AGENDA

CITY OF NORMAN, OK
HISTORIC DISTRICT COMMISSION MEETING
Municipal Building, Council Chambers, 201 West Gray, Norman, OK 73069
Monday, May 04, 2026 at 5:30 PM

ITEM TITLE: (HD 26-07) CONSIDERATION OF APPROVAL, REJECTION, AMENDMENT, AND/OR POSTPONEMENT OF THE CERTIFICATE OF APPROPRIATENESS REQUEST FOR THE PROPERTY LOCATED 413 S LAHOMA AVENUE FOR THE FOLLOWING MODIFICATIONS: A) CONSTRUCTION OF A DETACHED ACCESSORY DWELLING UNIT. (Postponed from the May 4, 2026, meeting).

ITEM TITLE: (HD 26-10) CONSIDERATION OF APPROVAL, REJECTION, AMENDMENT, AND/OR POSTPONEMENT OF AMENDMENTS TO CERTIFICATES OF APPROPRIATENESS 24-08 AND 25-04 FOR THE PROPERTY LOCATED AT 1320 OKLAHOMA AVENUE FOR THE FOLLOWING: A) MODIFICATIONS TO THE FRONT WALKWAY AND YARD; B) MODIFICATIONS TO THE EXTERIOR WALL MATERIALS; C) MODIFICATIONS TO THE GARAGE DOOR DESIGN; D) MODIFICATIONS TO WINDOWS. (Items A, B, and C were postponed from the April 6, 2026, meeting.)

ADU Option #2 - Alternative Option for Siding and Door

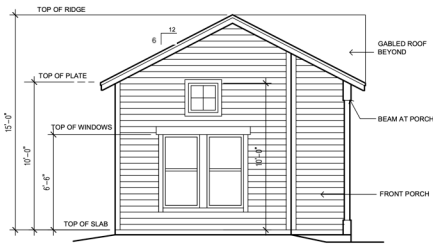
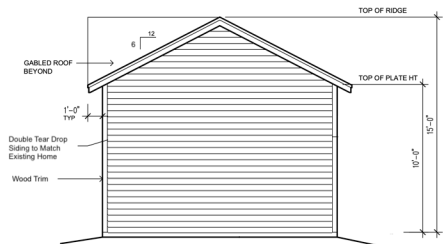
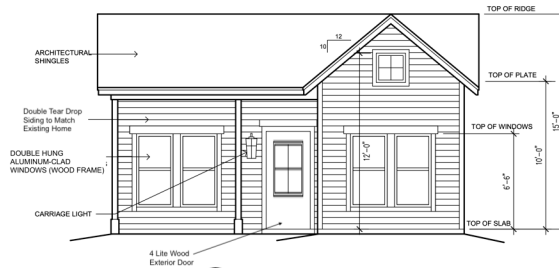
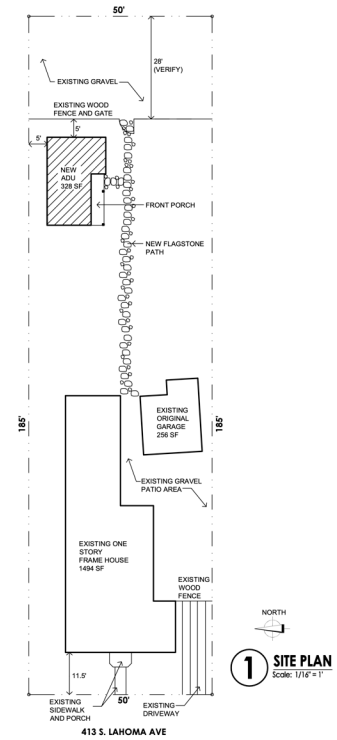
The Commissioners indicated that the *Guidelines for Accessory Structures* did not support the proposal to use alternative materials for the windows and doors. Additionally, some of the Commissioners cited a guideline, which states that the maximum wall height for an accessory structure is no greater than 10'. Furthermore, the Commissioners questioned whether the overall height of the ADU was in scale with the principal structure. The Commissioners requested additional information regarding the principal's ridge height. The Commissioners also found that the proposed eight-inch LP Siding was not compatible with the principal structure and the surrounding district. Finally, the Commissioners found there were no features or elements to tie this structure to the historic principal structure. Additionally, the applicant desired to relocate the requested ADU from the southeast corner to the northeast corner of the backyard. Due to the Commission's suggested revisions and the owner's proposal to relocate the ADU, the applicant requested a postponement to allow for the submission of revised drawings, a specification sheet, and additional information on the existing principal structure.

- a. Located in the rear yard, and not visible from front right-of-way.
- b. Compatible in design, style, and material to the principal historic structure and the surrounding historic neighborhood.
- c. Select materials and finishes for proposed new accessory buildings that are found in historic structures in the district in terms of composition, scale, pattern, detail, texture, and finish. Acceptable materials include brick and stone masonry, stucco and wood. Cement fiberboard will be considered on a case-by-case basis when there is limited visibility from the front right-of-way. Structures with no visibility from the front may utilize cement fiberboard. No metal or vinyl structures allowed.
- d. New accessory structures shall be one-story in height and less than 10 feet in wall height.

The applicant has submitted revised drawings showing the ADU located in the northeast corner of the yard. It will set back 5' from the north property line and 33' from the rear property line. The proposed ADU will have a wall plate height of 10' and a ridge roof height of 15' and will have a roof pitch of 12/10. Aluminum-clad wood windows are proposed.

The applicant has submitted two elevation drawings for the Commission's consideration. The two submitted ADU drawings are identical except for the exterior siding option and the entry door. ADU drawing #1 shows the preferred options of 6' LP Smart siding and a steel entry door. ADU drawing #2 shows alternative options for double-teardrop wood siding that would match the house and a wood entry door.

The submitted revised elevations propose aluminum-clad one-over-one wood windows that meet the *Guidelines for Accessory Structures* and match the windowpane configuration of the historic principal structure.

The use of lap siding, one-over-one aluminum-clad wood windows, and a gable design similar to that of the principal structure will provide a "nod" to the historic home. The use of modern materials, such as LP Smart lap siding and a steel entry door, will differentiate the ADU from the principal structure, thereby avoiding a false sense of history.

1- Upgraded proposed front entryway walkway

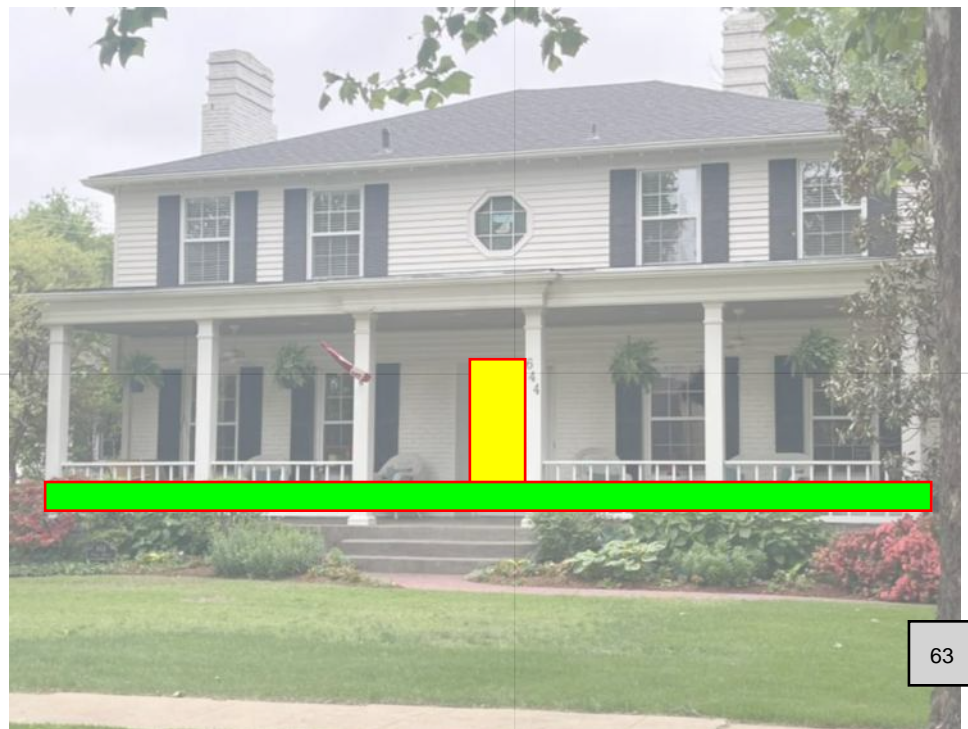
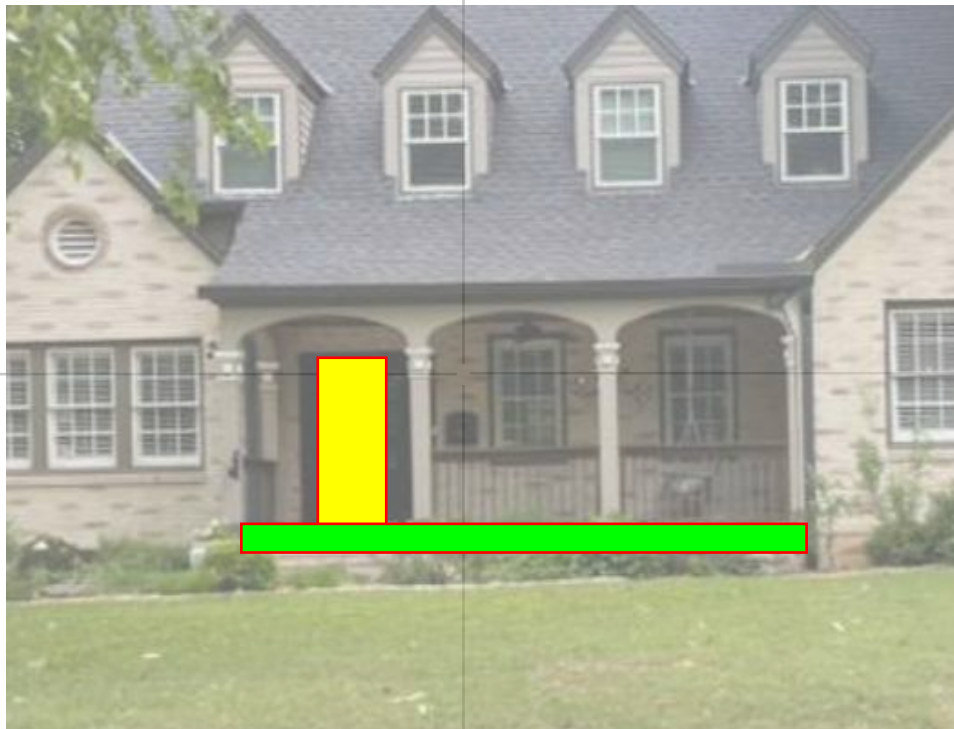
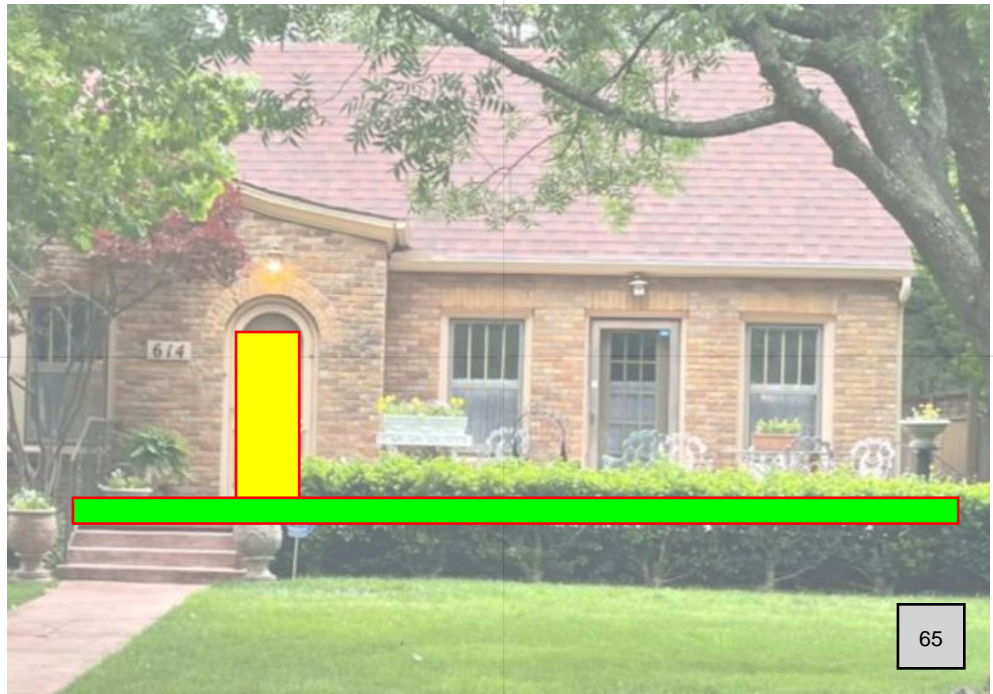
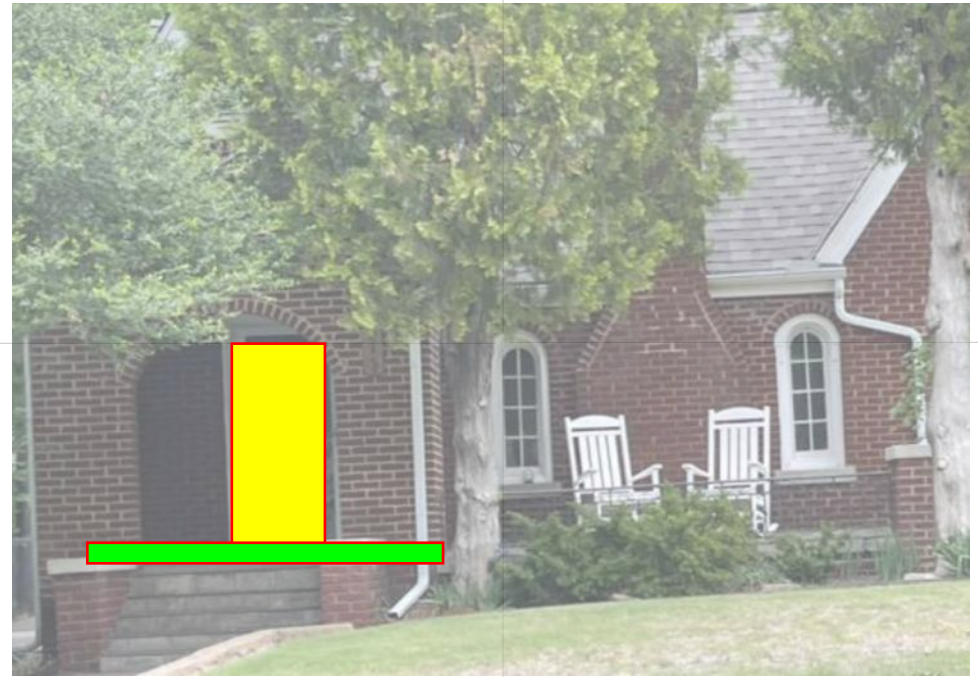
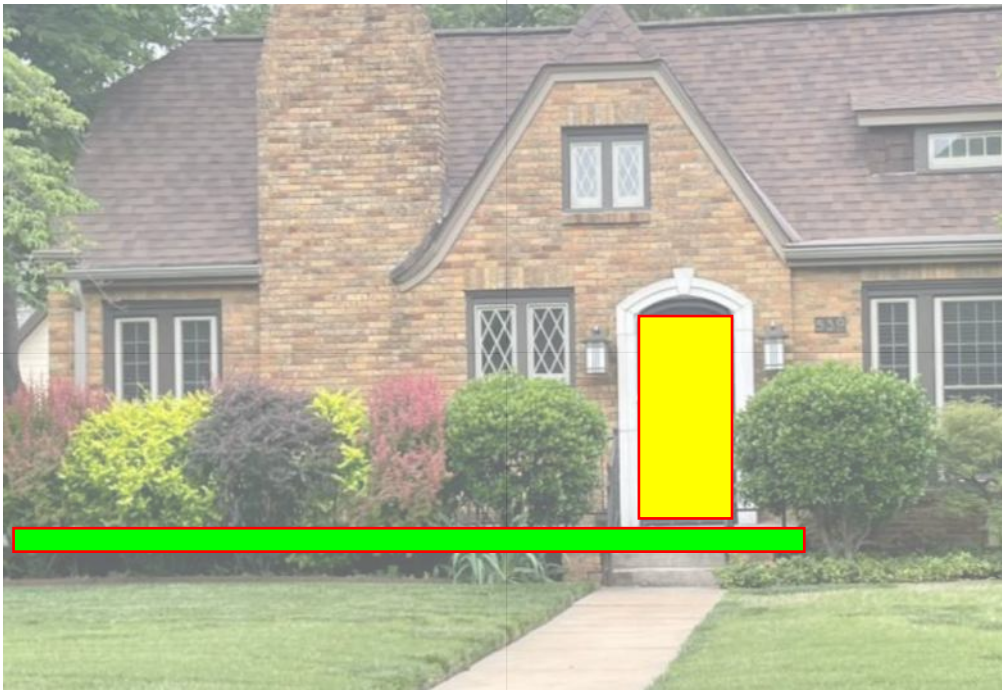
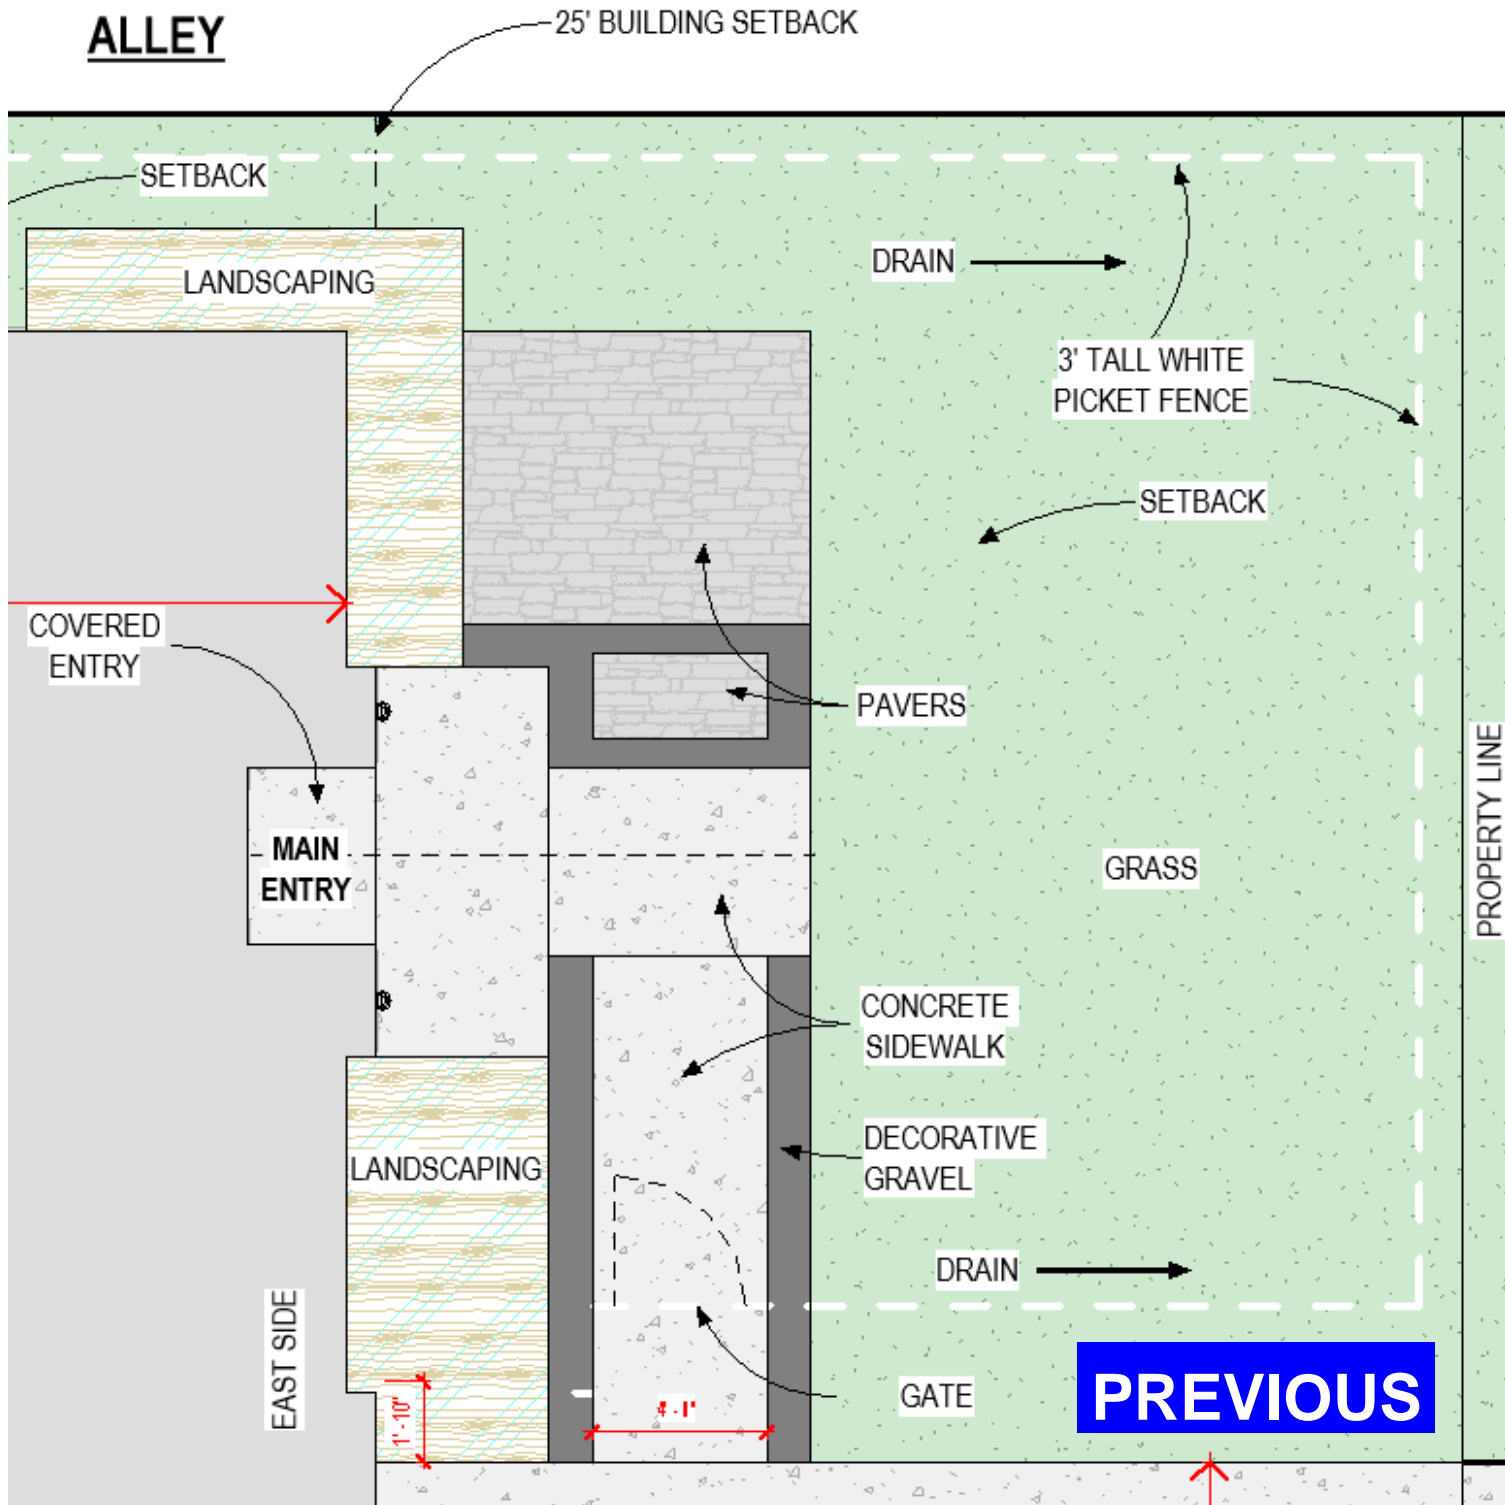
The applicant is now proposing to expand the front walkway and add a patio to provide a more formal entrance path to the house. All three submitted options propose adding pavers adjacent to the driveway at the beginning of the walkway. Such a configuration is not typically found in the Southridge Historic District.

The applicant is also proposing to add pavers and concrete near the front entryway to create a patio. The *Guidelines* state “paved areas should be compatible in location, configuration, and materials with existing walkways” and “shall not overwhelm the principal structure”. A request for a front-yard patio is unusual for the historic districts and has not been requested before. It should be noted that this is a non-contributing structure and is the only structure in the Southridge Historic District to front onto Oklahoma Avenue. However, the proposed entryway is not compatible with other parcels in the Southridge District in terms of location, configuration, and materials. The addition of any of the proposed options would have an impact on the streetscape on one of the entryways to the Southridge Historic District.

The Commission needs to determine whether the proposed modifications to the walkway and yard meet the *Preservation Guidelines* and are compatible with this structure and the Southridge District.

2- Upgrade exterior materials

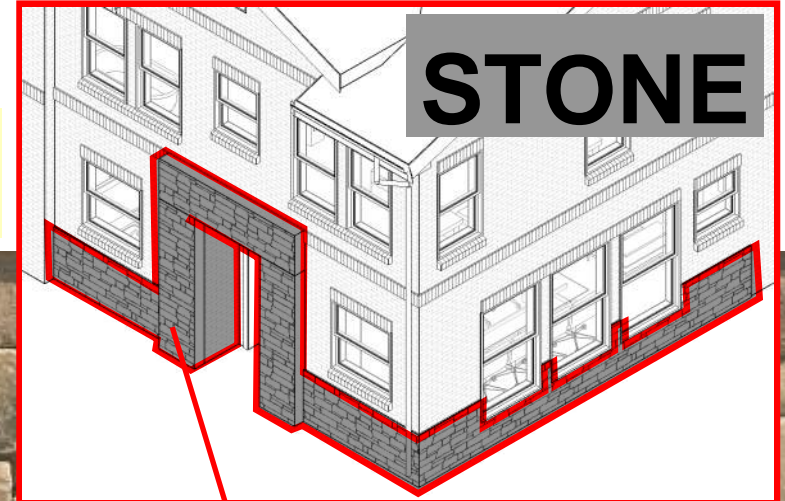
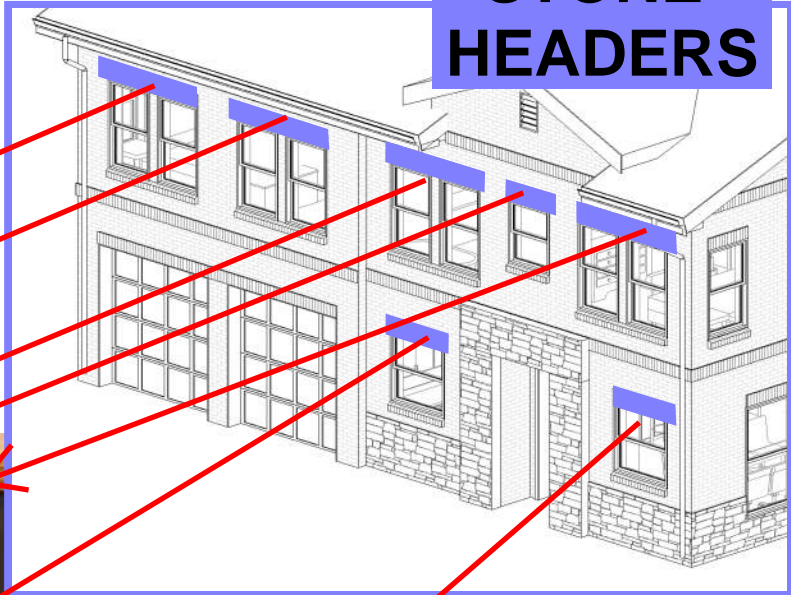
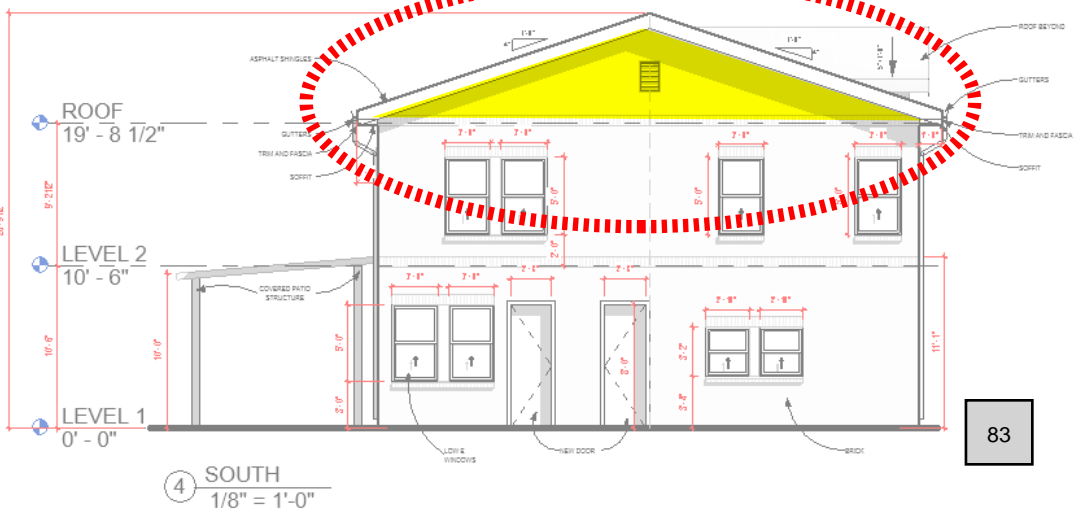
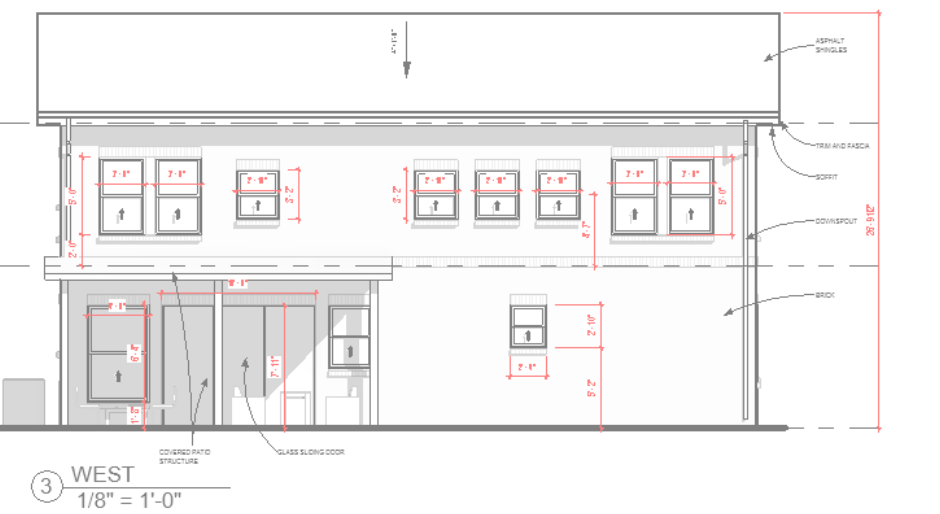
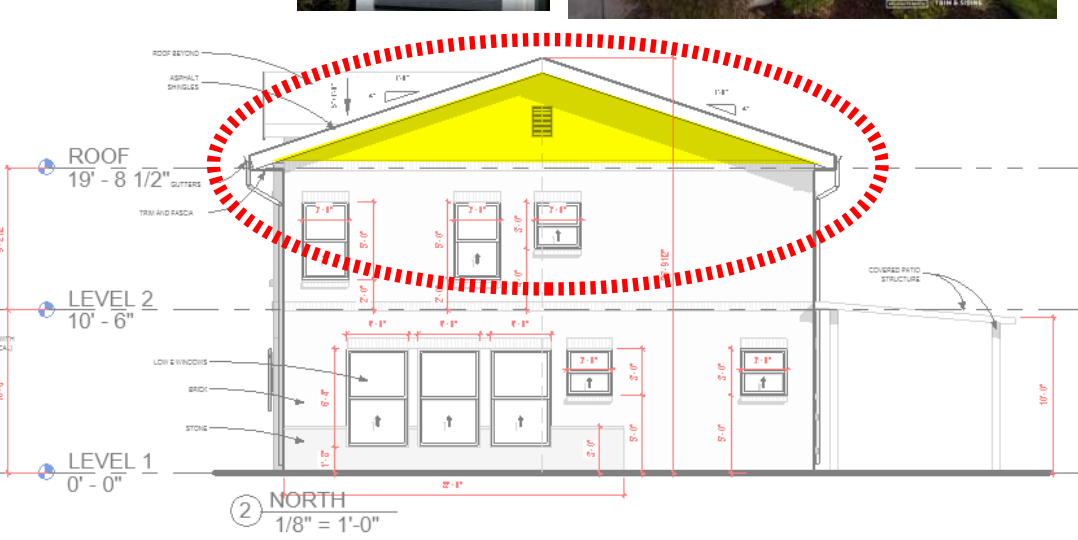
typical of the district. The applicant has added LP Smart siding to the gable to reduce the amount of brick, as the Commission suggested at its April meeting earlier this year. The Guidelines also state that new primary structures are to be a design of their own time while being compatible with the surrounding district. However, the Preservation Guidelines encourage the inclusion of elements or features found in the surrounding historic district in new primary structures. In this case, the proposed scale and design of the brick and stone exterior are not typical exterior wall finishes found on historic structures in Southridge Historic District.

At the March 8, 2025, Historic District Commission meeting, the Commission approved a COA for a new house. At that time, the applicant proposed LG Smart lap siding for the exterior walls with a cedar surround for the entryway. The applicant is now requesting an amendment to the COA to replace the lap siding with brick as the main exterior wall material, along with a stone surround entryway. Stone accents above the window and wainscot are also proposed. The applicant has eliminated the cedar trim details

proposed at the April 4, 2026, meeting and has added LP Smart siding in the gable areas near the roofline. The applicant has submitted an elevation drawing and a color rendering to illustrate these proposed exterior material modifications.
